Access Compliance Report

Public Rights-of-Way

(Curb Ramps)

Intersection ID: 48470	Main Street: HALTON_PARK_DR	Cross Street: UNIVERSITY_CITY_BV	Location: NW
ADA ID: 8B5B4B0BA360	Ramp Type: Perp	Initial Pass/Fail: Fail	Overall Compliance: No
Severity Score: 33.75			
Codes/Mitigation Info/Possible Solution		Field Measurements/Component Compliance

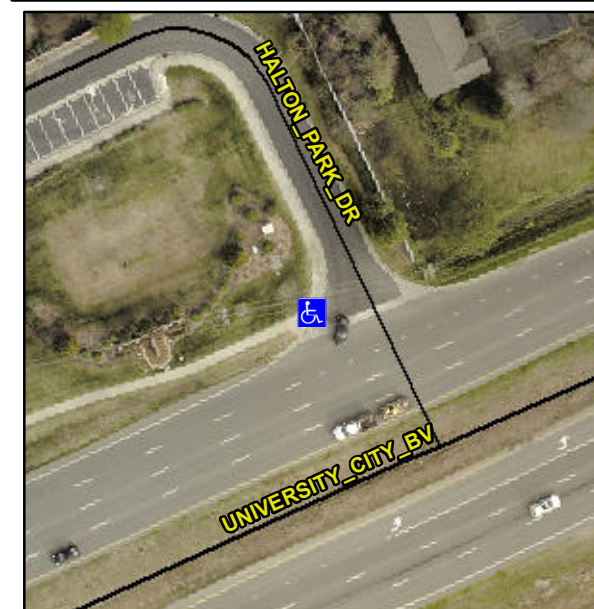
R304.5.1, R304.2.2

Compliance	Description	Data	Compliance	Description	Data
N/A	Ramp Length (in)	61.0	No	Ramp Slope (%)	16.0
No	Ramp Width (in)	47.0	Yes	Ramp XSlope (%)	0.3
N/A	Flare Type LT	N/A	N/A	Flare Type RT	N/A
N/A	Flare Slope LT (%)	N/A	N/A	Flare Slope RT (%)	N/A
N/A	Flare Traversable LT?	N/A	N/A	Flare Traversable RT?	N/A
N/A	Landing Length (in)	N/A	N/A	DWS Provided?	N/A
N/A	Landing Width (in)	N/A	N/A	DWS Contrast?	N/A
N/A	Landing Slope (%)	N/A	N/A	DWS Length (in)	N/A
N/A	Landing X Slope (%)	N/A	N/A	DWS Full Width?	N/A
N/A	Landing Curb? (Y/N)	N/A	N/A	DWS Offset (in)	N/A
N/A	Shared Landing?	N/A			
N/A	Gutter Ponding?	N/A	N/A	Gutter Slope (%)	N/A
N/A	Gutter Lip Ht (in)	N/A	N/A	Gutter X Slope (%)	N/A
N/A	Painted X Walk1?	No	N/A	Painted X Walk2?	N/A
	X Walk 1 Direction	To E		X Walk 2 Direction	N/A
N/A	X Walk 1 Width (in)	N/A	N/A	X Walk 2 Width (in)	N/A
	X Walk 1 Slope (%)	3.8		X Walk 2 Slope (%)	N/A
	X Walk 1 X Slope (%)	0.8		X Walk 2 X Slope (%)	N/A

Remove & Replace Entire Ramp.
